DATE 12 May 1964		TMC SPECIFICATION NO. S.826	C
SHEET 1 OF 8			
LB COMPILED	LB CHECKED	TITLE:	
DB APPROVED

VSWR PROTECTION FOR GPT-40
KIT-160

To provide control circuitry to protect transmitter and line from high standing wave ratio.

Figure 1

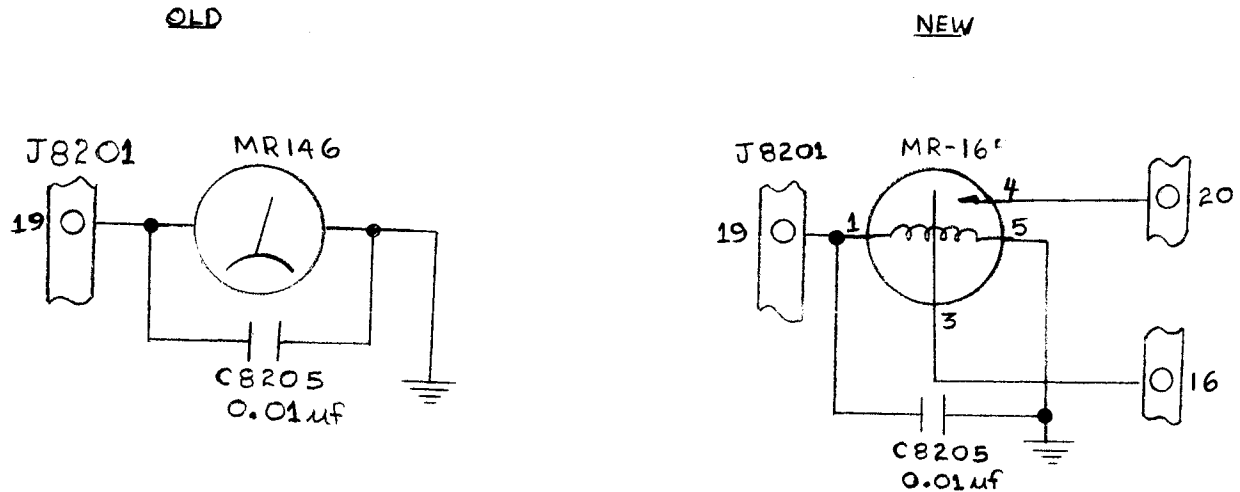
1. Remove all power to the equipment.
2. Place antenna tuner unit on bench and replace SWR meter, MR146, with SWR meter MR165 (Item 1). Retain capacitor C8205 (.01).
3. Install one length of Green/White #20 wire (Item 6) from Pin 16 on J8201 to contact #3 on back of MR165. Also, install one length of Red/White #20 wire (Item 7) from Pin 20 of J8201 to contact #4 on back of MR165. Fit black plastic sleeving (Item 16) over solder connections to J8201, and lace both of these new leads to the existing cable with lacing cord (Item 10).
4. Contact #1 on MR165 connects to the existing input lead from Pin 19 of J8201.
5. Contact #5 on MR165 connects to the existing ground lead.
6. Connect C-8205 (removed from MR146) between contacts #1 and #5 on MR165.

The rewired ANTENNA TUNER DRAWER should correspond to the following new schematic:

Figure 2

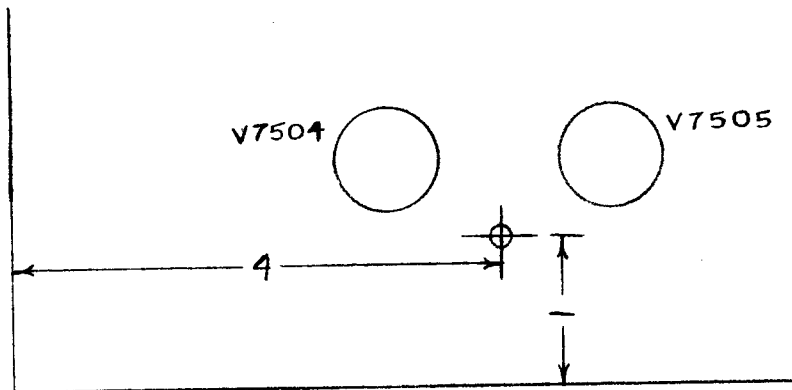
11. Referring to Figure 2, drill a hole with (Item 15) #30 Twist Drill to accommodate (Item #11) TE-102-2, Terminal, Turret.

Figure 3

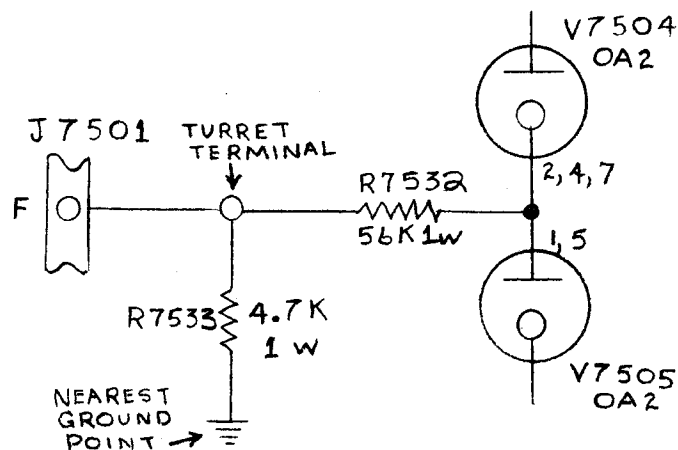
12. Mount turret terminal, (Item 11), with (Item 12) and (Item 13), screw and washer. Solder the two divider resistors (Item 2 and Item 4) as shown in Figure 3). Solder a length of White/Red #20 wire (Item 6) from turret terminal to bias supply plug J7501, Pin F. Insulate Pin F with Item 16 (sleeving, insulation). Lace wire to existing cable with (Item 10).

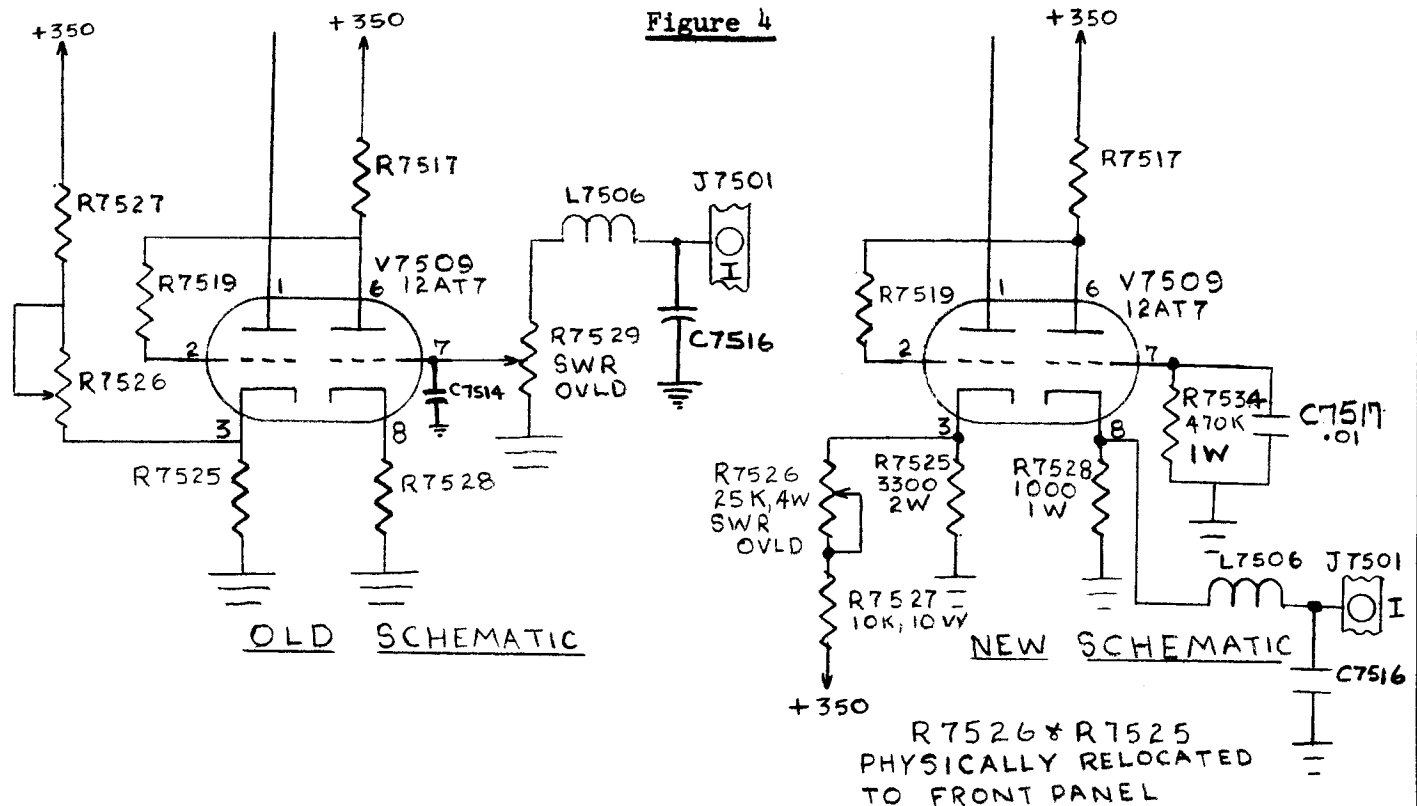
23. Solder the 470K (1W) resistor (Item 3), and the .01 uf capacitor (Item 5) between Pin 7 of V-7509 and ground, (refer to Figure 4).

24. Solder a length of Red/White #20 wire between Pin 8 (V-7509) and the side of L-7506 that was described in Step 19. Lace this new wire to the main cable.
25. Replace tubes V-7504, V-7505 and V-7509. The rewired SWR d-c amplifier should conform to schematic Figure 4.
